**FOURTH FIVE-YEAR REVIEW REPORT FOR  
PINETTE'S SALVAGE YARD SUPERFUND SITE  
AROOSTOOK COUNTY, MAINE**

**U.S. Environmental Protection Agency  
Region 1  
Boston, MA**

**Photo #1. MW-1 Well Cluster (Access is impeded by standing water, junked vehicles, and vegetation, and bollards are no longer vertical). May 2015.**

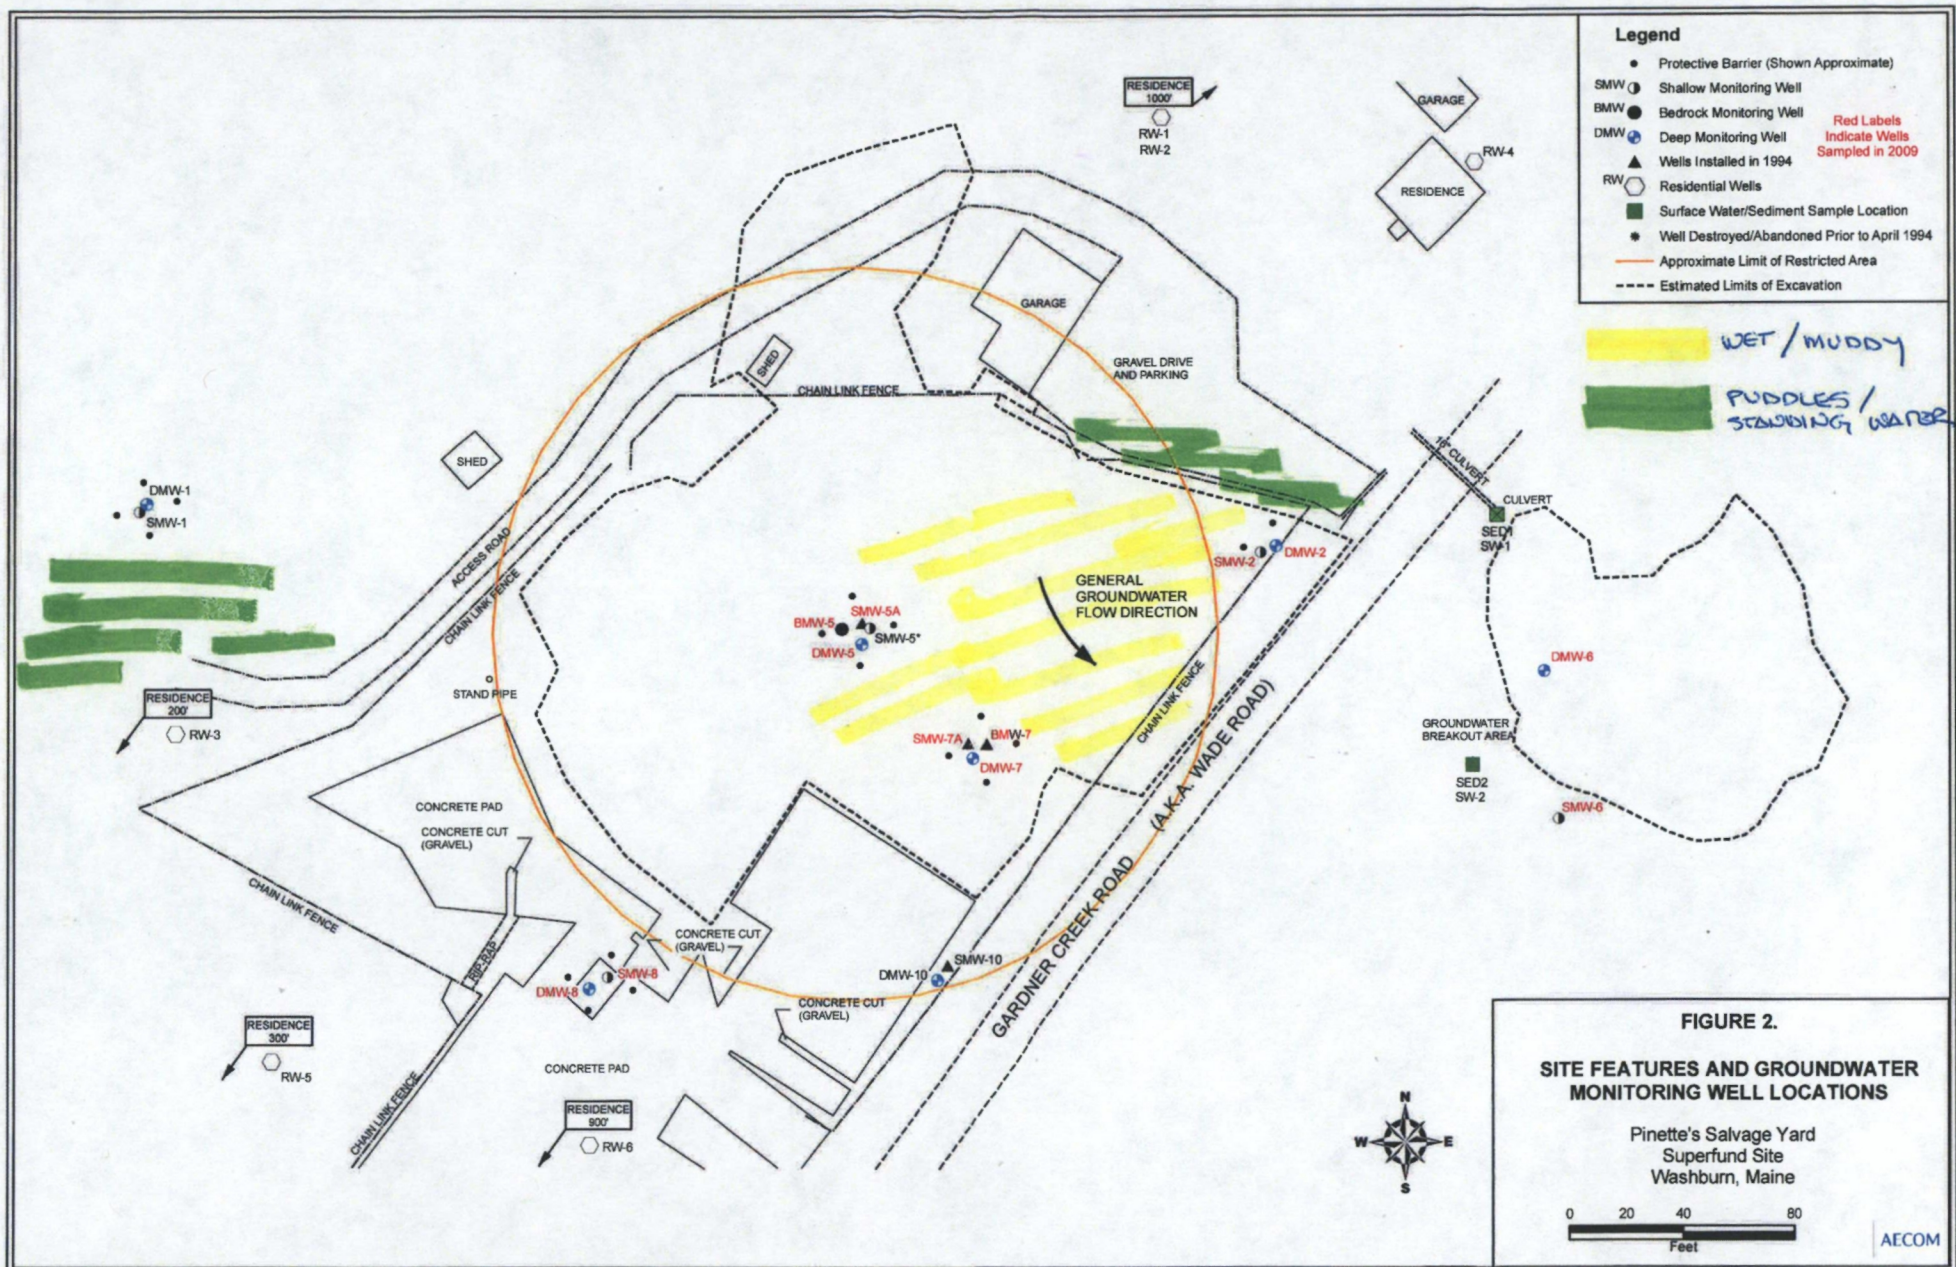
Photographs showing the seven well clusters (MW-1, -2, -5, -6, -7, -8, and -10) that remain at the Site are included in Appendix E. In 2015, the monitoring wells were found to be locked (with two exceptions) and in reasonably good condition. Problems that were noted include the following: 1) many of the well protective casings appear to have been forced upwards, possibly by freeze/thaw cycles; 2) many of the bollards that surround the wells to protect them from vehicles are bent over, some severely; 3) access to the upgradient MW-1 cluster is slightly restricted by junked vehicles and standing water (although the standing water is probably a temporary springtime condition, caused by recent snowmelt and rainfall); 4) the caps on the protective pipes on wells SMW-10 and SMW-2 cannot be locked because the PVC well casings are above the top of the protective pipes (probably due to settlement of the protective pipes); and 5) access to the MW-10 cluster is slightly restricted by junked vehicles, vegetation, and the fence that separates the wells from Gardner Creek Road.
